Design Report  
for  
*Northern and Butler Storm Drains*  
*Sub-Phase "A"*

Northern/Orangewood  
Storm Drain Project  
Contract FCD - Phase II

February 24, 1998  
WP #94153.02

The 90% review comments are incorporated into this submittal. The 90% review comments and responses are included under separate cover.

BUTLER DRIVE

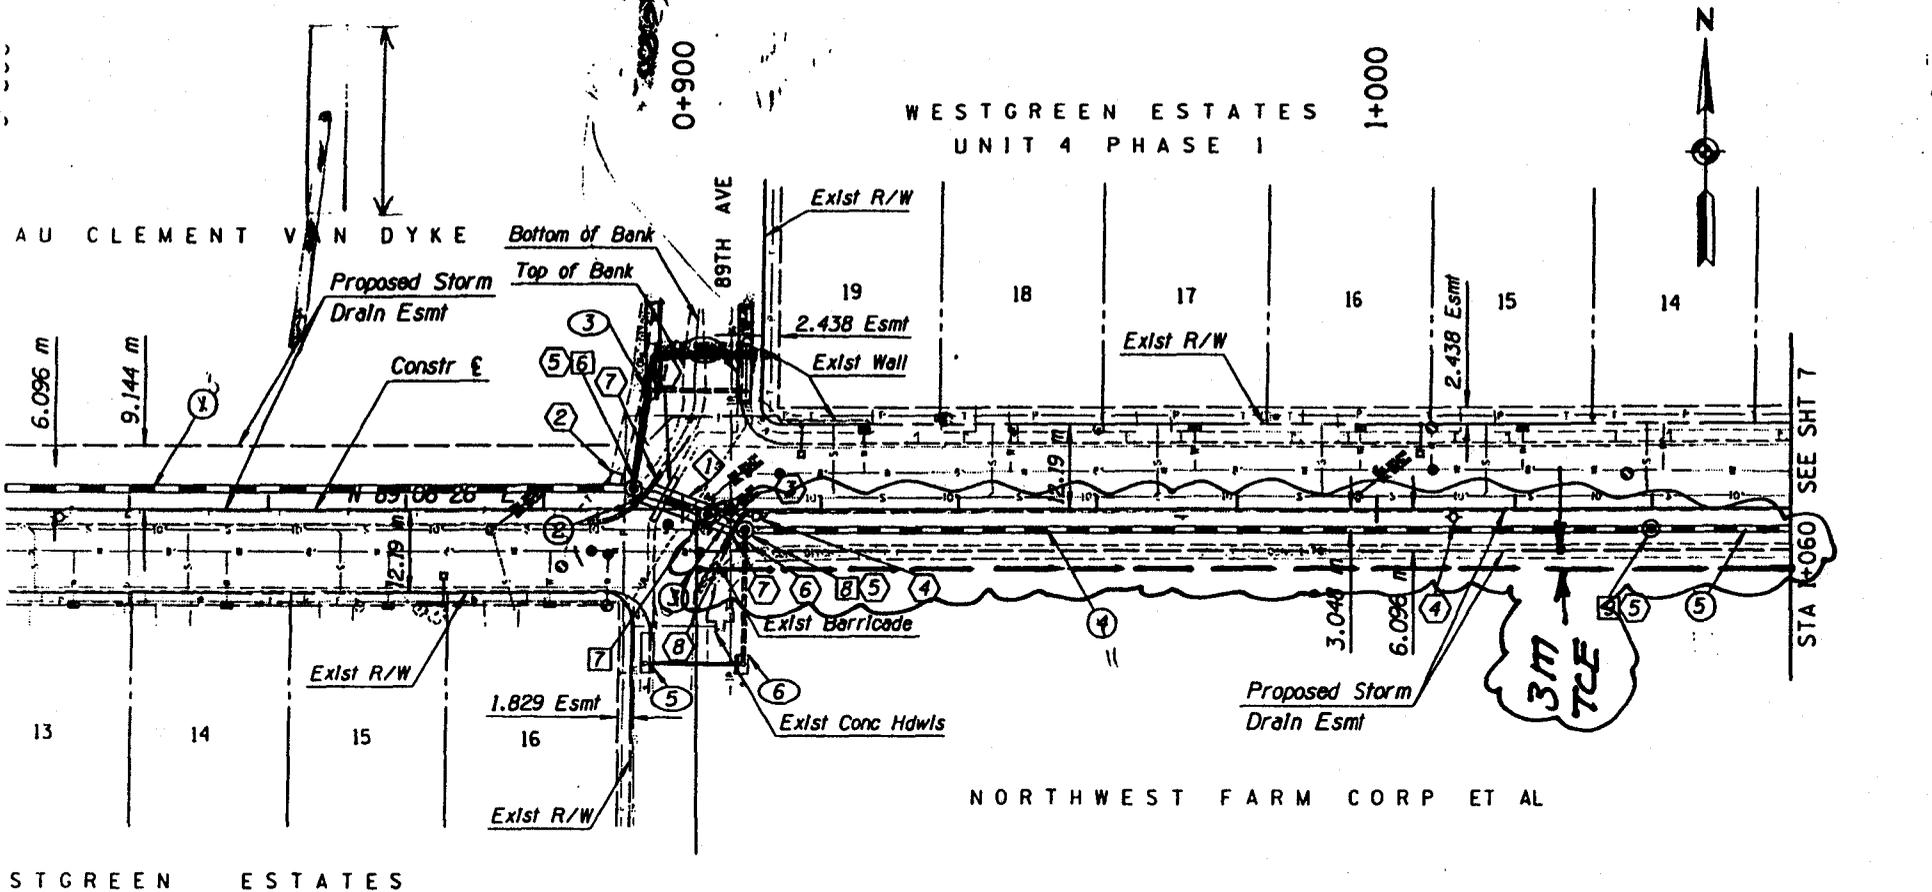
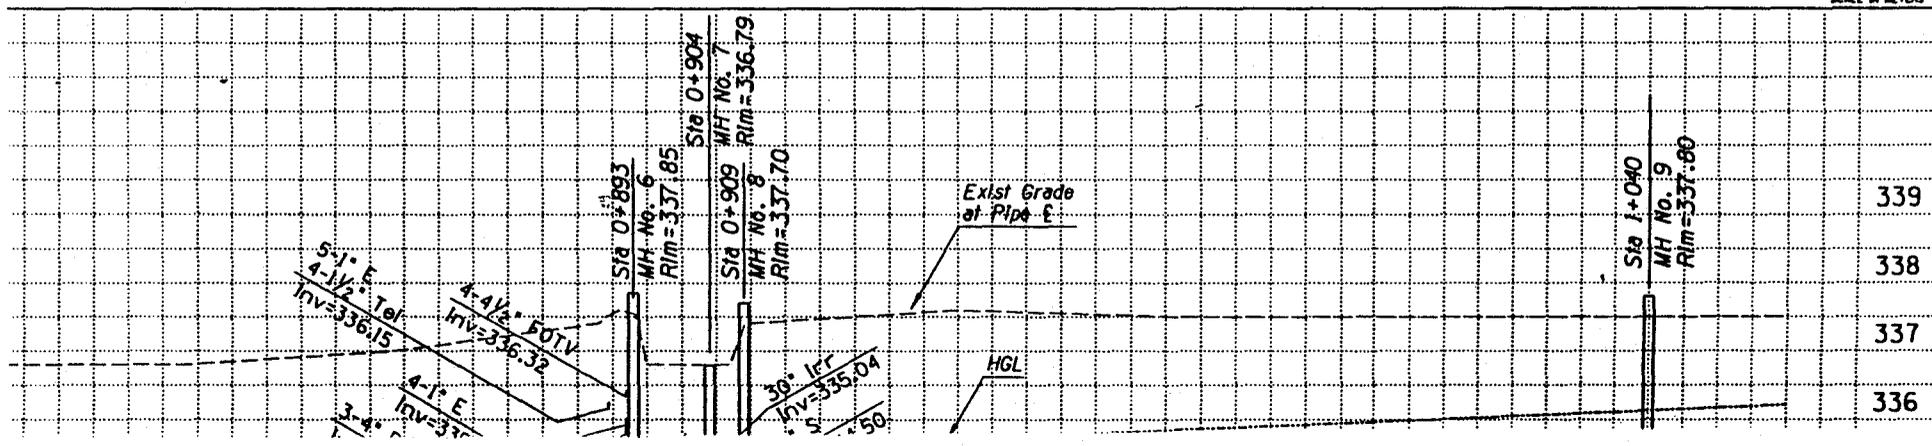
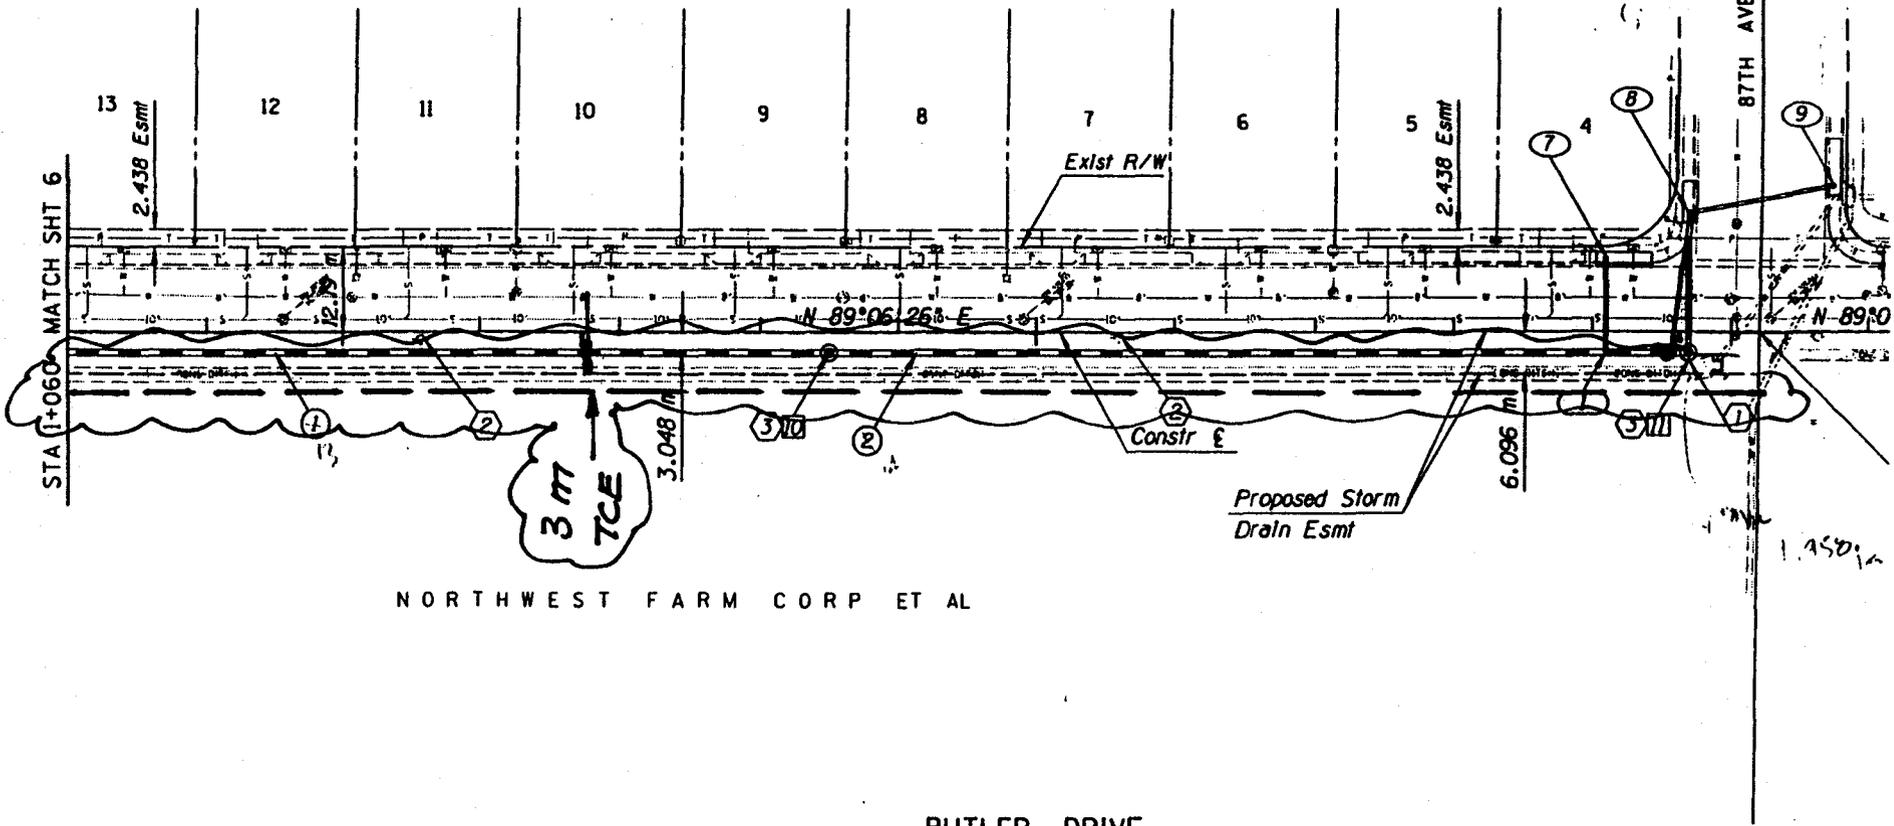
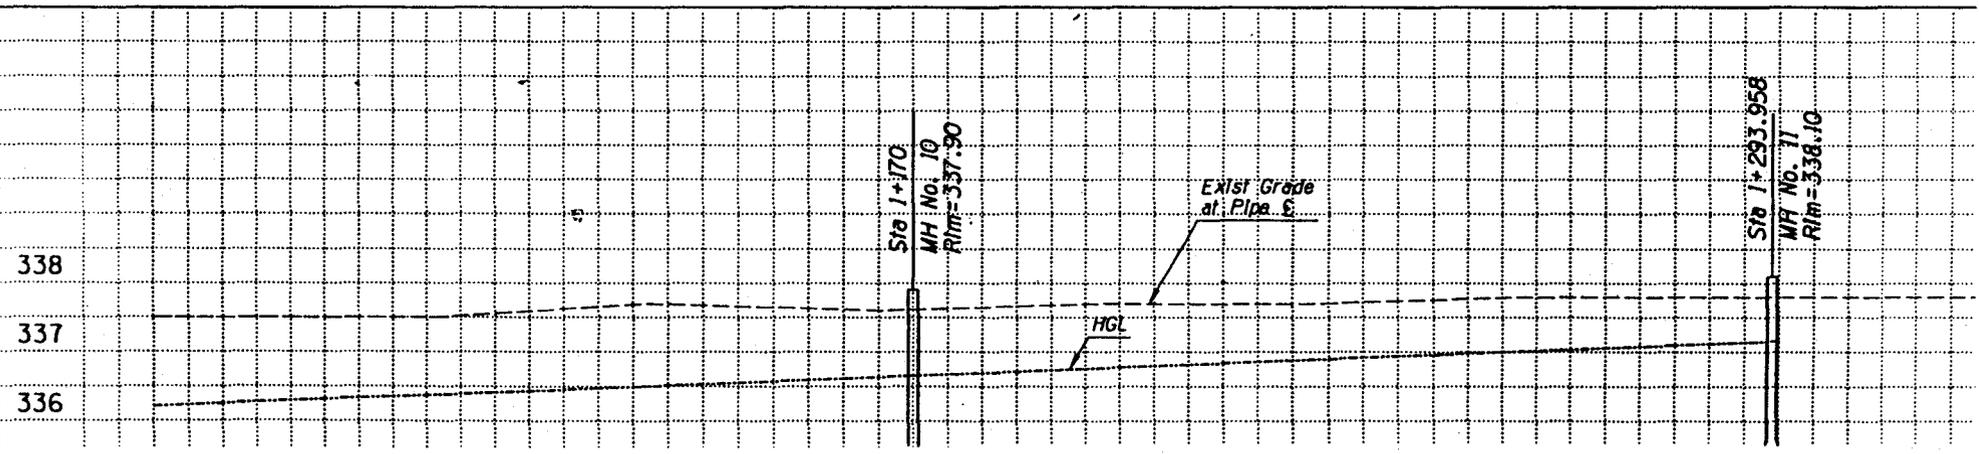
Per our discussion this morning, I am sending you a copy of the sheets for Butler Drive between 89<sup>th</sup> Ave. and 87<sup>th</sup> Ave. As shown on plans, we are requesting a 6.096 m (30 foot) Storm Drain Easement.

In order to remove and replace the existing concrete lined irrigation "v" ditch which parallels this alignment, we will need an additional 3 m (10 foot) Temporary Construction Easement immediately to the south of the storm drain easement.
